REVISION TRANSMITTAL

This sheet transmits Revision 1 to SB525-34-97, which:

NAVIGATION - GARMIN SOFTWARE UPDATE TO VERSION 4.8.11

SB525-34-97
Page 1 of 20

Figure 1. Wiring Modification (Sheet 1)

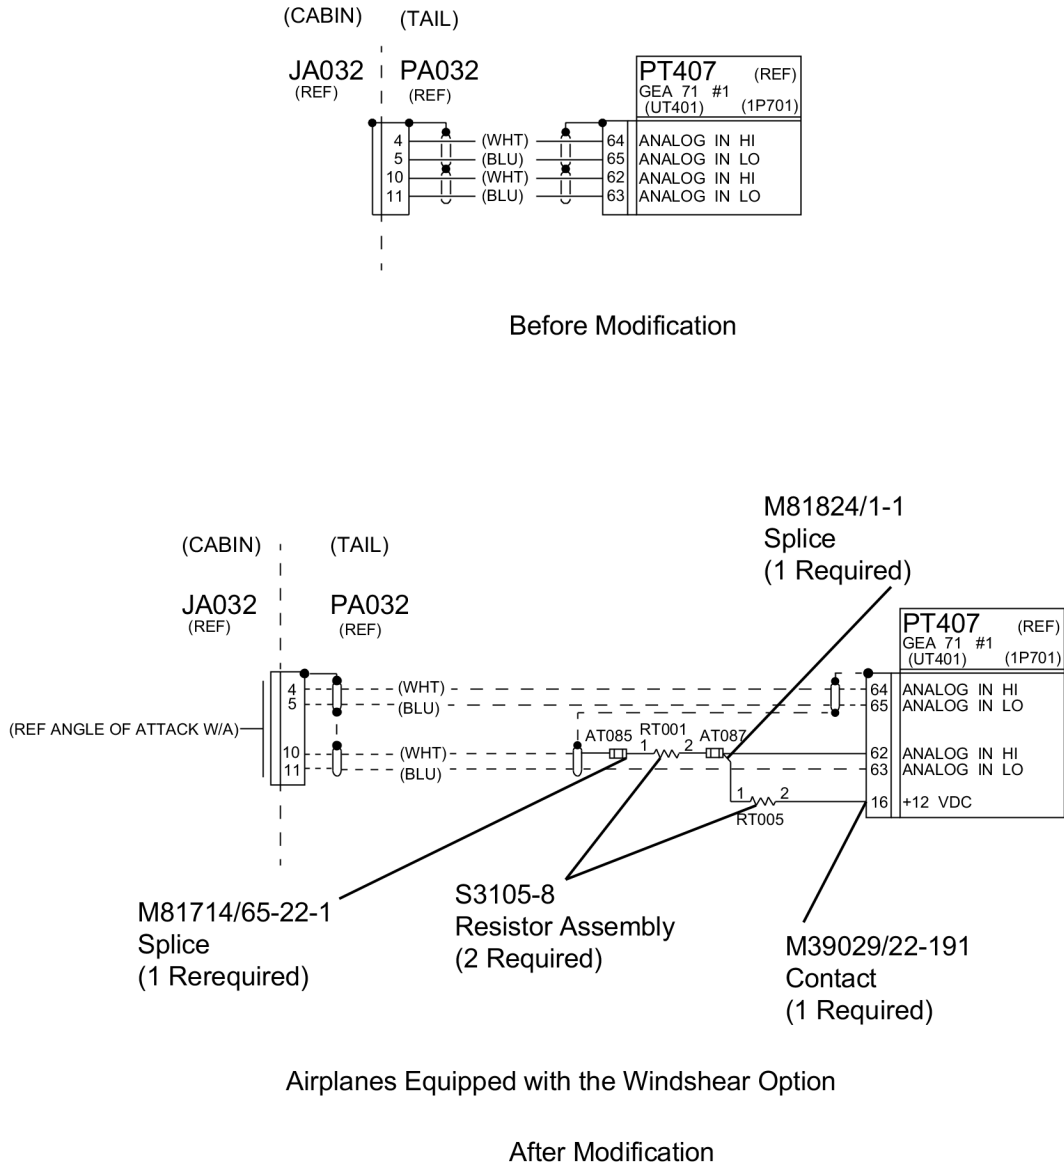
4. (Airplanes equipped with the Stormscope option) Modify the wiring.
 - A. Open the left nose baggage compartment door.
 - B. Remove nose baggage compartment panels 211DZ and 211LZ to get access to the left GIA63W Integrated Avionics Unit. (Refer to the Model 525 (0685 and 0800 and On) Maintenance Manual, Chapter 6, Access Plates and Panels Identification - Description and Operation.)

- G. Remove the PN409 electrical connector from the left avionics pallet.
 - H. (Refer to Figure 1, Sheet 1.) Install the 26PN836-77PN409 Electrical Wire using two M39029/58-362 Connector Pins.

- I. (Refer to Figure 1, Sheet 1.) Install the 77J3-70P606 Electrical Wire using two M39029/58-362 Connector Pins.
 - J. Install the PN836 electrical connector in the Stormscope processor.
